Mask Change for all Spartan-6 FPGA Devices, Speed File Change for -3N Devices

XCN11012 (v1.0) April 18, 2011

Product Change Notice – For Information Only

Figure 1: Package Topmark

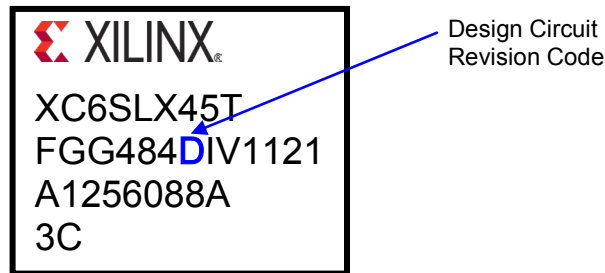
Production Spartan-6 FPGA devices will begin transitioning to a new mask revision. The new mask revision changes the IODELAY2 errata noted in [EN148](#). The mask changes are limited to the IODELAY2 circuit within each I/O. This is considered a minor change and is drop-in compatible. There is no change to functionality relative to the software and documentation, other than the change to the IODELAY2 errata in [EN148](#). The new silicon is bitstream compatible to the current silicon. The new mask revision is indicated by a change in the topmark circuit revision code and by a change in the JTAG IDCODE revision.

Affected devices are identified by the design circuit revision code as shown in the following package topmark.
